Docket Item # 3 & 4
BAR CASE # 2013-00044
2013-00045

BAR Meeting
March 20, 2013

ISSUE: Permit to Demolish &
Certificate of Appropriateness

LOCATION: 109 South Washington Street and 112A South Columbus Street

SOUTH ELEVATION
SCALE: 1/8" = 1'-0"
16

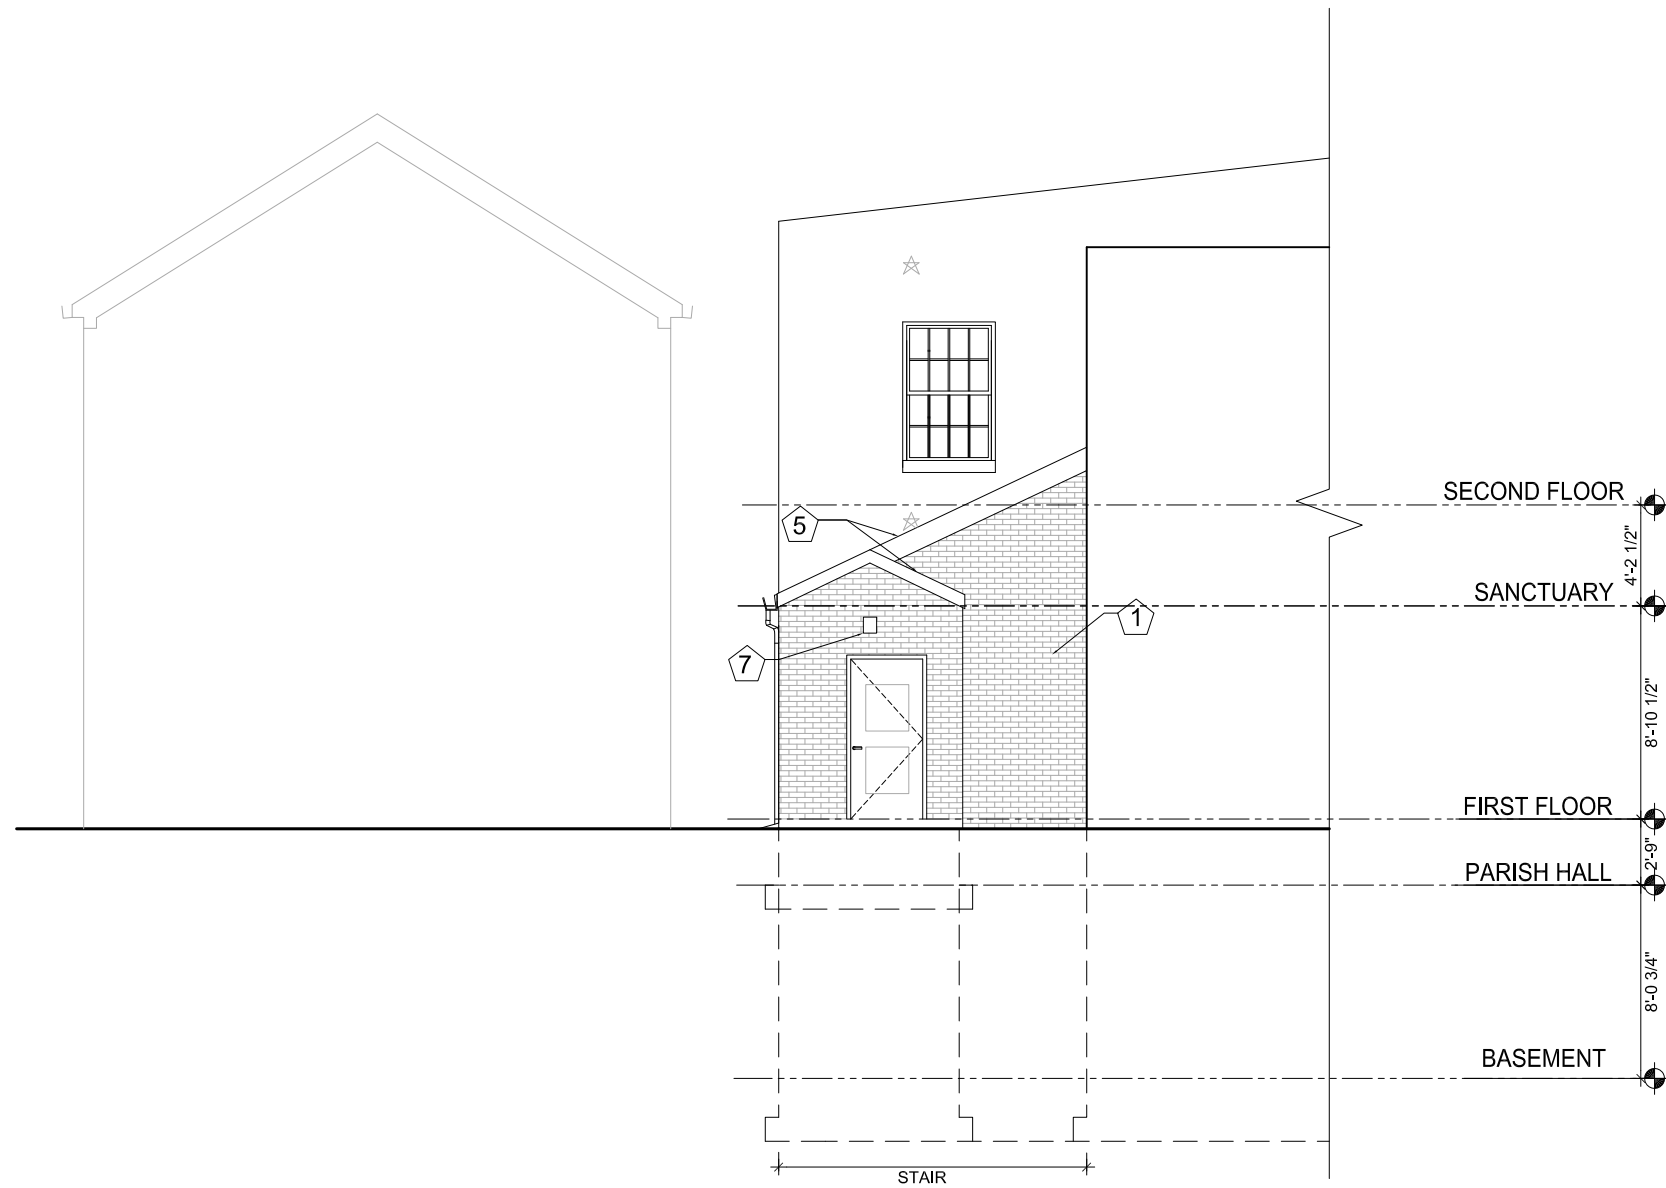
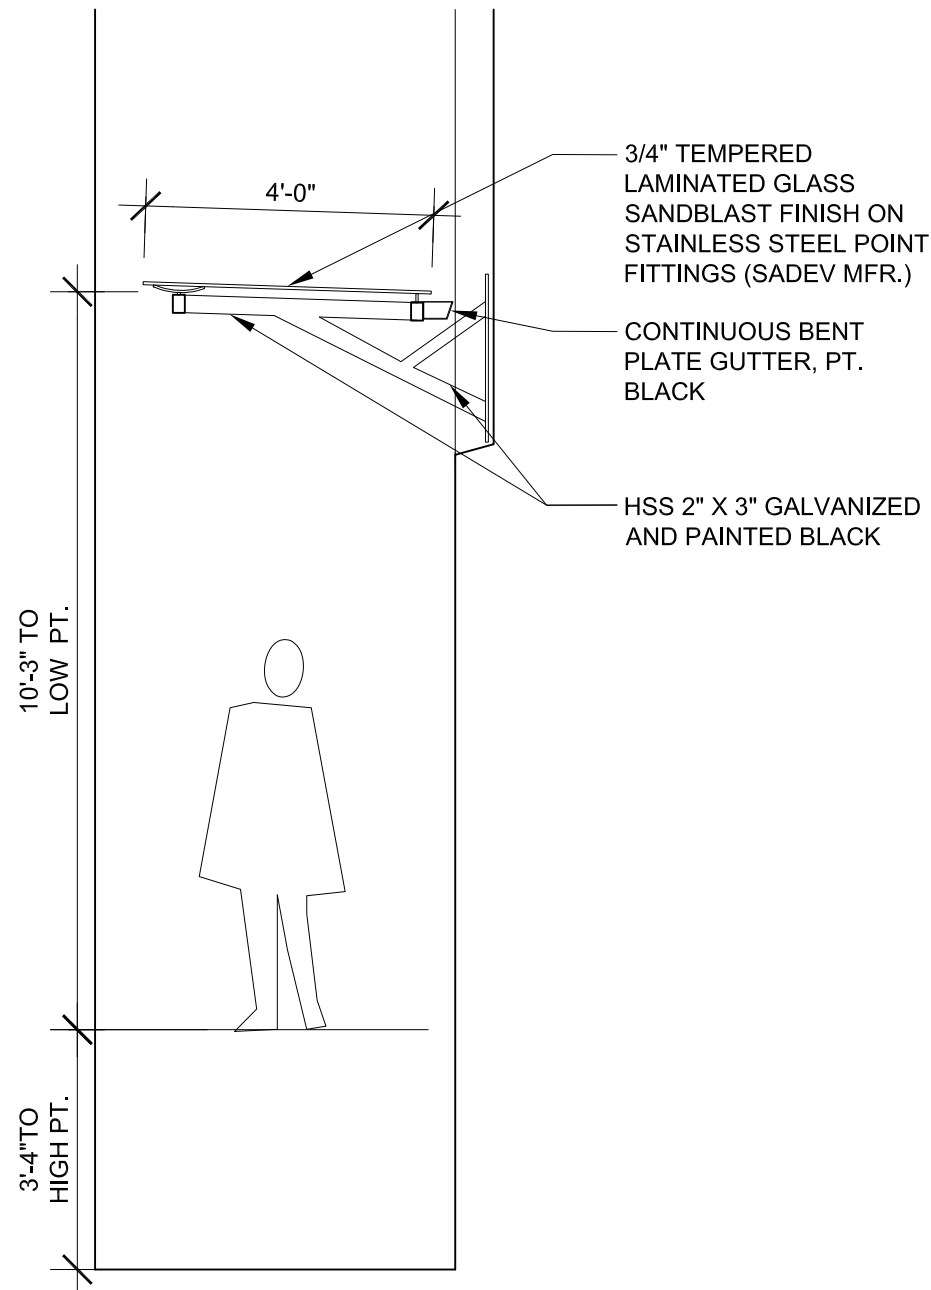
Through the choice of materials and design, the applicant has clearly differentiated the new access ramp and canopy from the historic structure to which it is attached. The design is compatible in size and scale and does not damage the integrity of the 19th century church or its environs. The National Park Service (NPS) has expressed concern with the proposed design and has indicated a preference for replicative, Colonial Revival style doors, window, light fixtures, and canopy with pediment. NPS does acknowledge that the alterations will be minimally visible from South Washington Street.

BAR Staff, respectfully, disagrees with NPS and notes that the existing church is a magnificent example of the Italian Renaissance Revival style that has nothing to do with the Colonial Revival period. Further, the proposed minimalist glass canopy appears to conform with the Secretary of the Interior Standards for Rehabilitation, specifically items #9 & #10, below.

Staff notes that the proposed canopy and gate are set back significantly from the east façade of 109 South Washington Street and will be visible only when directly facing the narrow alley, so it will have no effect on the spatial relationships that characterize the historic property. The canopy structure is elegantly detailed and appears to float between the walls of both buildings. The canopy and gate are, therefore, easily reversible with minimal impact to the historic walls. The proposed iron gate is a security feature that references the side yard gate at 112A South Columbus Street.
